09-AFC-3

Subject: Mariposa Energy Project (09-AFC-03)

Re: Comments to Staff Assessment November 2010, CEC 700-2010-017

BEFORE THE ENERGY RESOURCES CONSERVATION AND DEVELOPMENT
COMMISSION OF THE STATE OF CALIFORNIA
1516 NINTH STREET, SACRAMENTO, CA 95814
1-800-822-6228 – WWW.ENERGY.CA.GOV

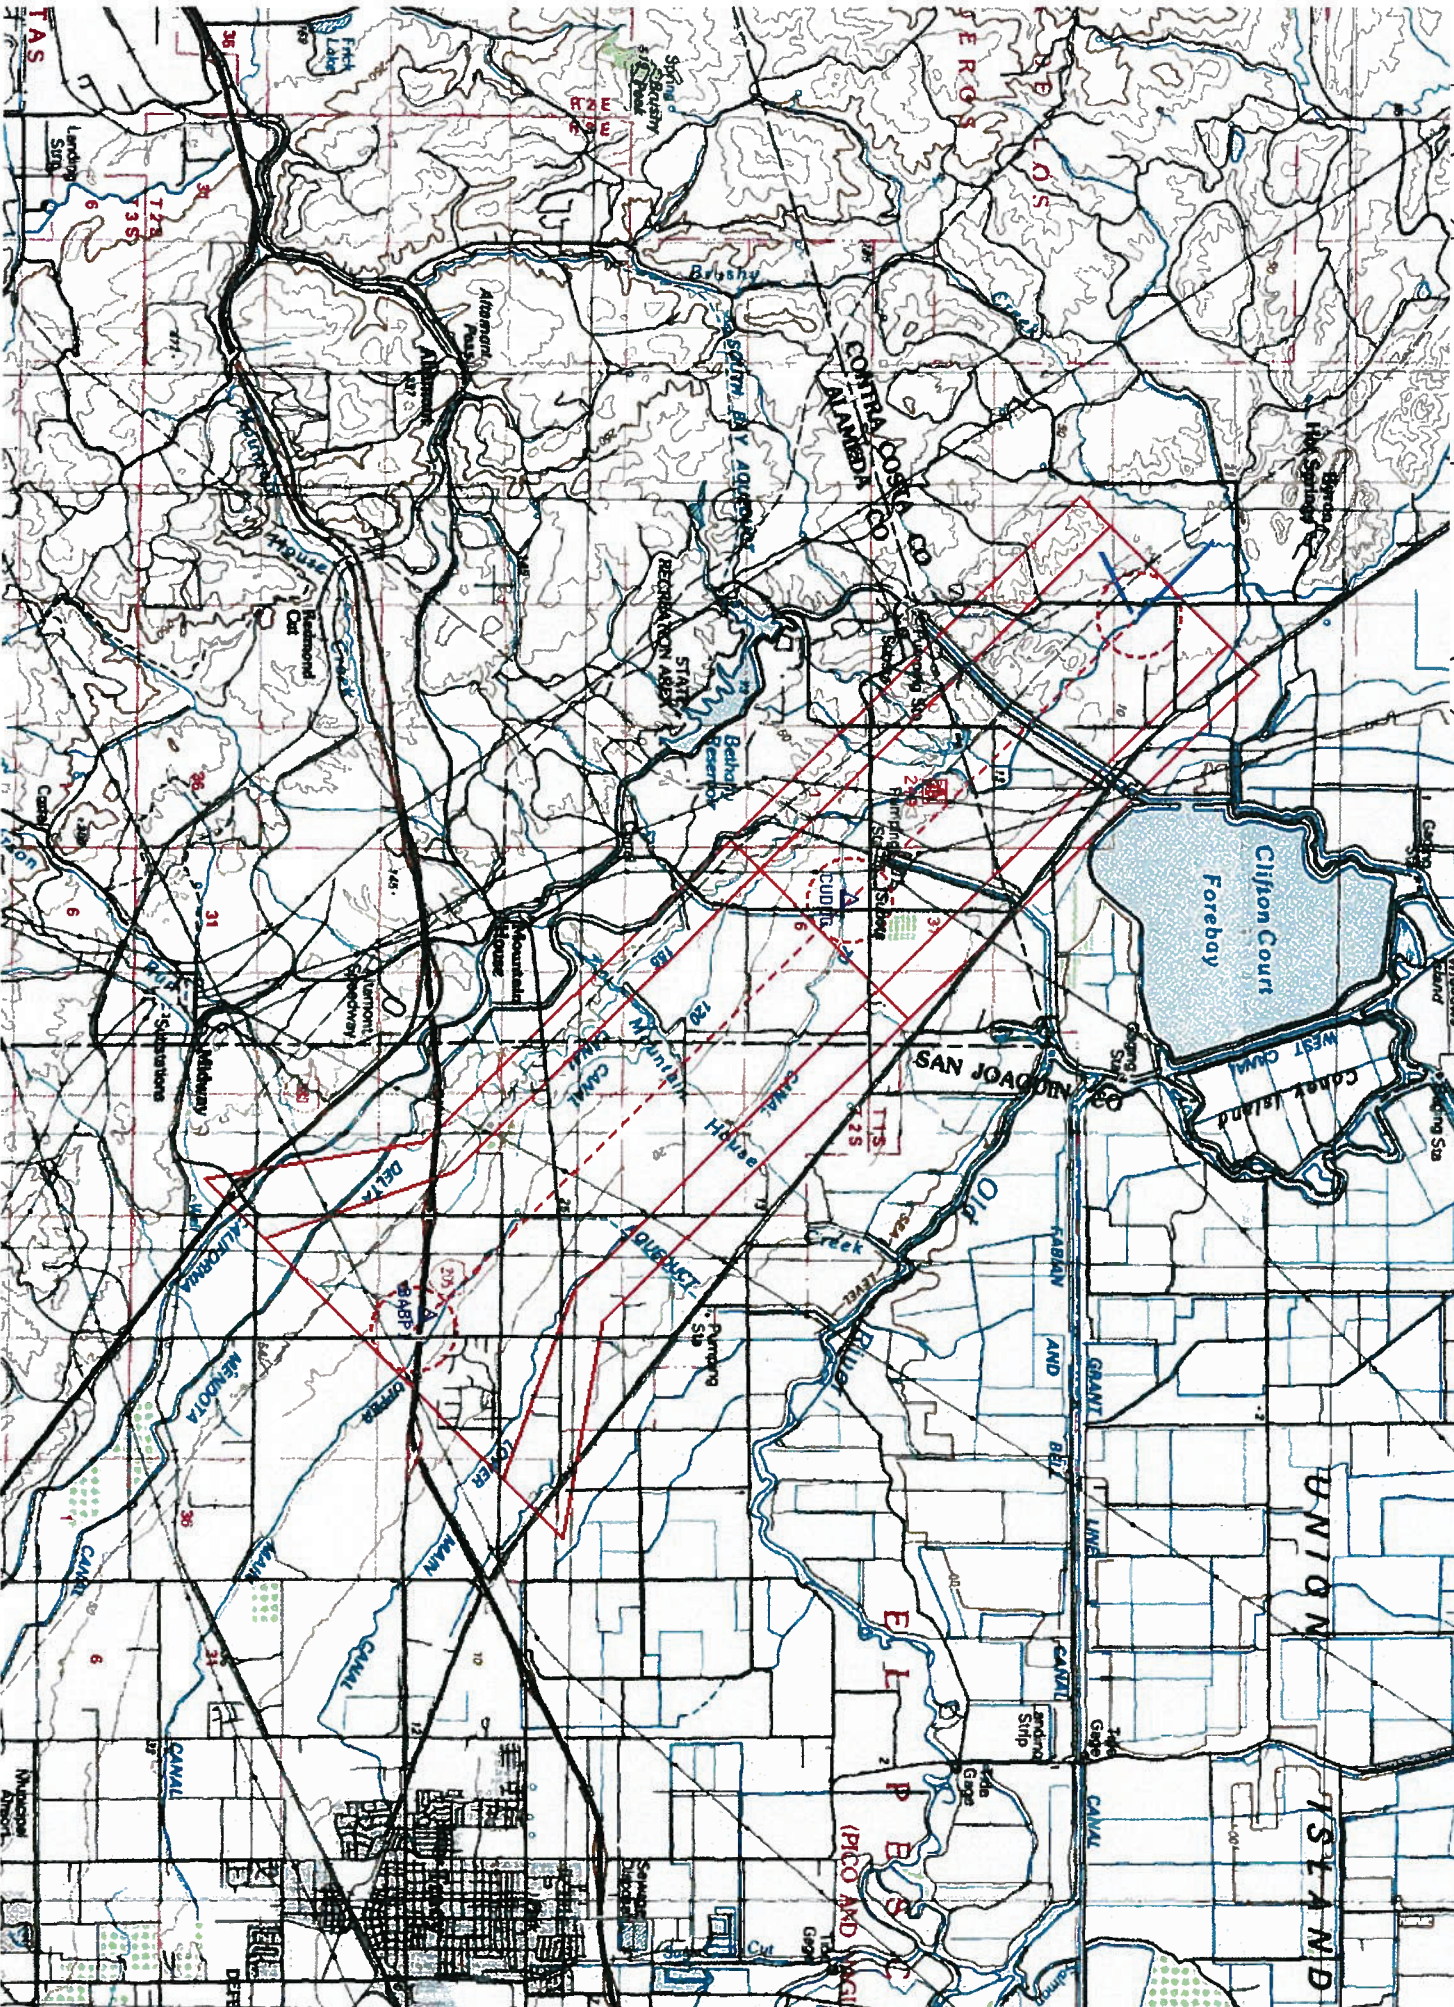
CALPILOTS Requests CEC Staff to review and calculate the horizontal obstacle / hazard clearance to the RNAV Approach to the Byron Airport (C83) RNAV Approach to Runway 30 (Attachment 1) and as per U. S. Department of Transportation, Federal Aviation Administration (FAA), National Policy, Order 8260.54A, And Effective Date: 12/07/07, Subj.: The United States

This should be applied but not limited to Mariposa Energy and East Altamont. East Altamont would not only have the invisible thermal plumes but the visible plumes as well. Both would interfere with the Obstacle Clearance Surfaces to Runway 30.
